N400NAS6

TECHNICAL BULLETIN

SAFETY RECALL: Startup Battery Ground Stud - Insufficient Ground Contact

MODEL:	MODEL YEAR:	VIN:
Discovery (LR)	2019-2020	400085-443301

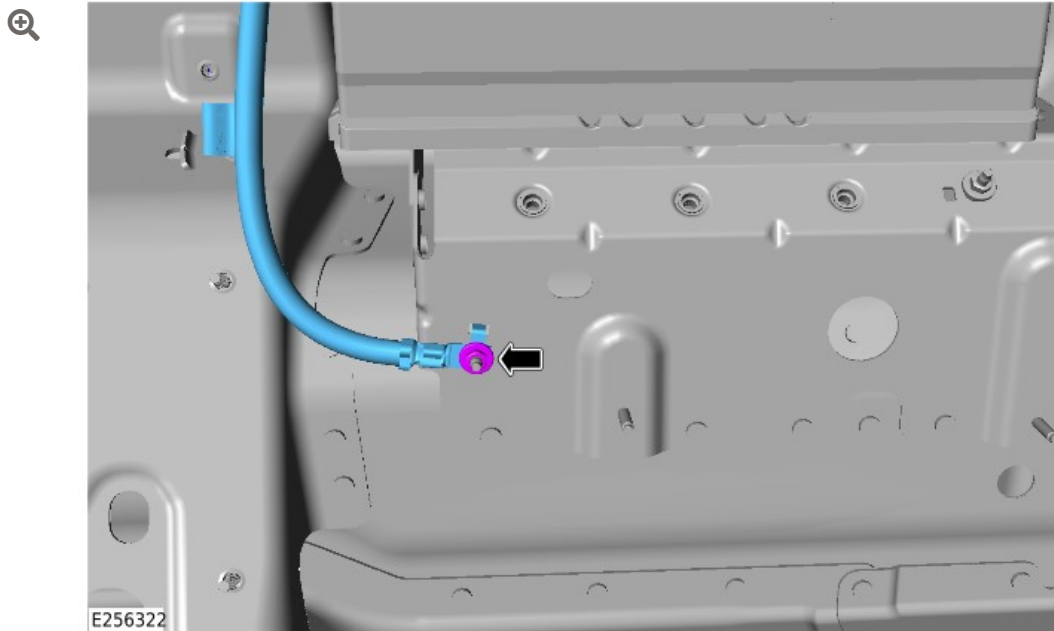
Remove the startup battery ground cable from the body ground stud (G4D178).

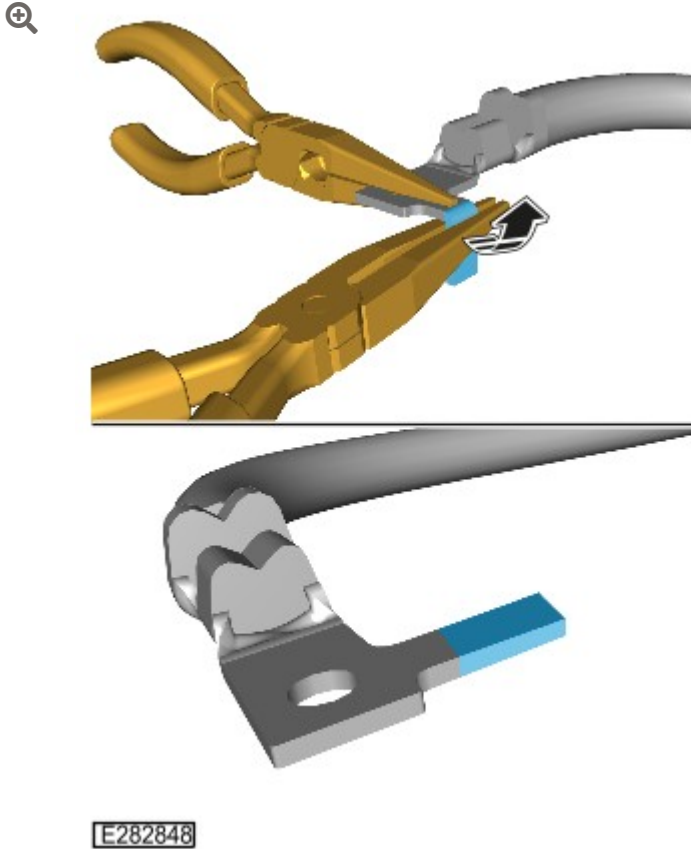
Special tool JLR-MRPK4075 or JLR-MRPK4081 MUST be used to install a new ground stud.

Use special tool JLR-MRPK4075 or JLR-MRPK4081 to install a new body ground stud (LR149837) 50 mm above the existing ground stud (see TOPIx Workshop Manual section 501-25A: Body Repairs General Information - General Procedures - Body Earth Stud Repair).

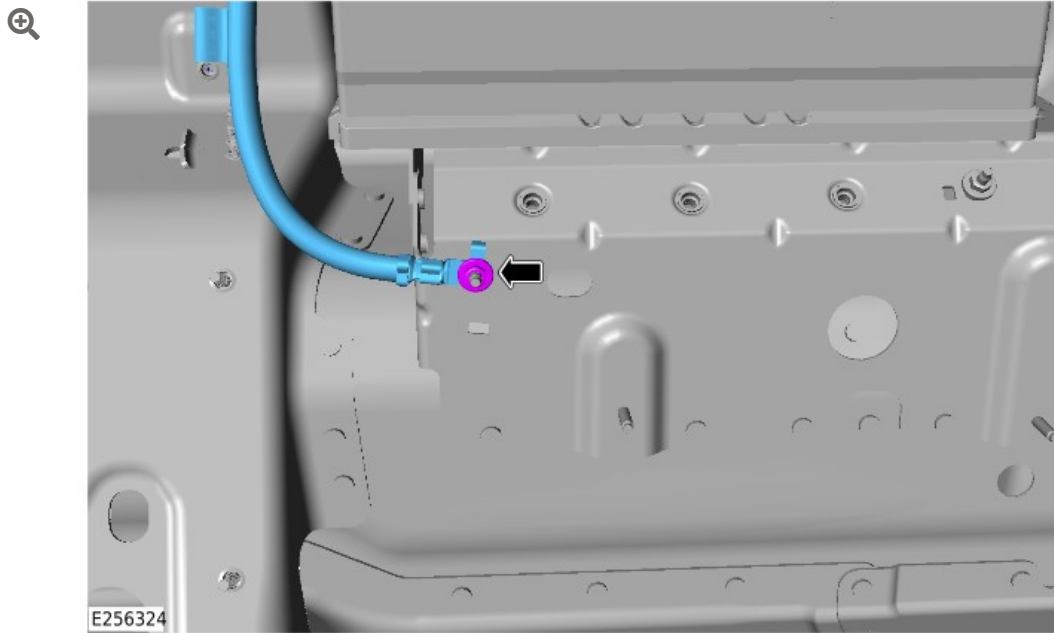
Use 2 pairs of suitable pliers to carefully straighten the startup battery ground cable locating tab, making sure the eyelet is held securely so the surface remains level while the locating tab is straightened.

The surface of the startup battery ground cable eyelet **MUST** be flat prior to installation.

Install the startup battery ground cable to the new body ground stud.

- Torque: **8 Nm**

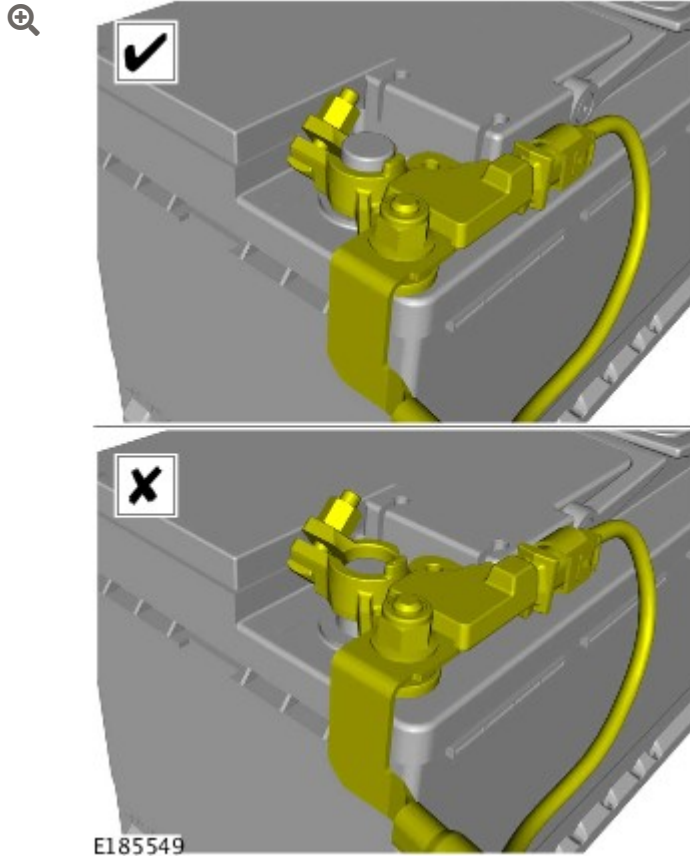
Make sure the battery terminal is in the correct position.

Connect the startup battery ground cable (see TOPIx Workshop Manual section 414-00: Battery and Charging System - General Information - Specifications).
